Federal Aviation Administration  
Aviation Rulemaking Advisory Committee

Transport Airplane and Engine Issue Area  
Loads and Dynamics Harmonization Working Group

**Task 15 – Structural Integrity of Fuel Tanks for Emergency Landing  
conditions and Landing Gear**

Revised Requirements for the Structural Integrity of Fuel Tanks

**Figure 3- Example of Distances For Fuel Forward Acting  
Design Pressure Calculations**

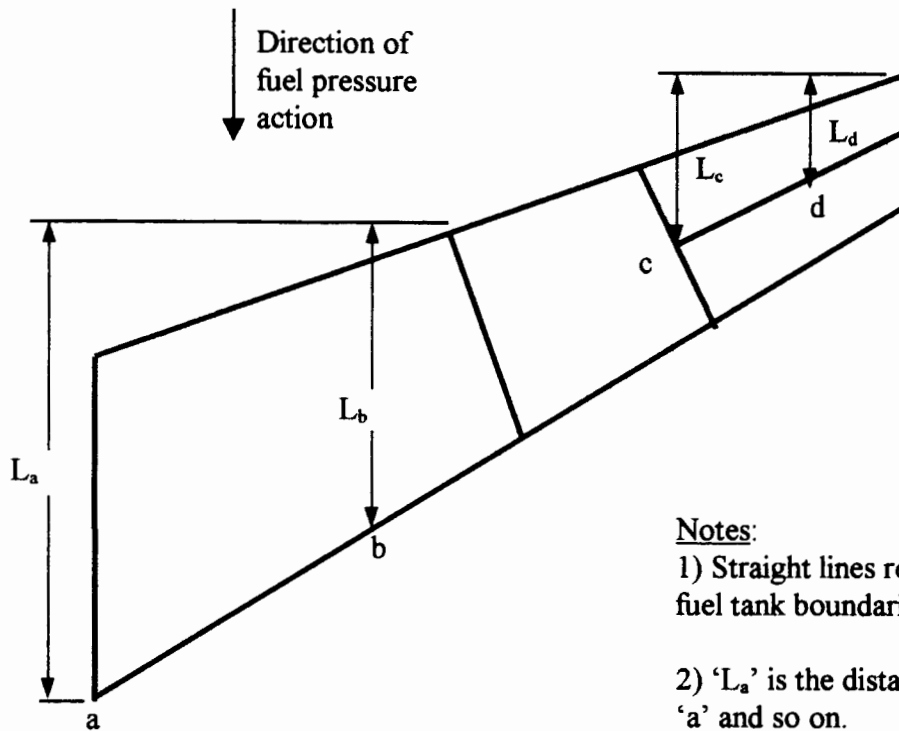
The equation for fuel tank pressure uses a factor L, based upon fuel tank geometry. Figure 3 shows examples of the way L is calculated for fuel pressures arising in the forward loading condition, while Figure 4 shows examples for fuel pressures arising in the outboard loading condition.
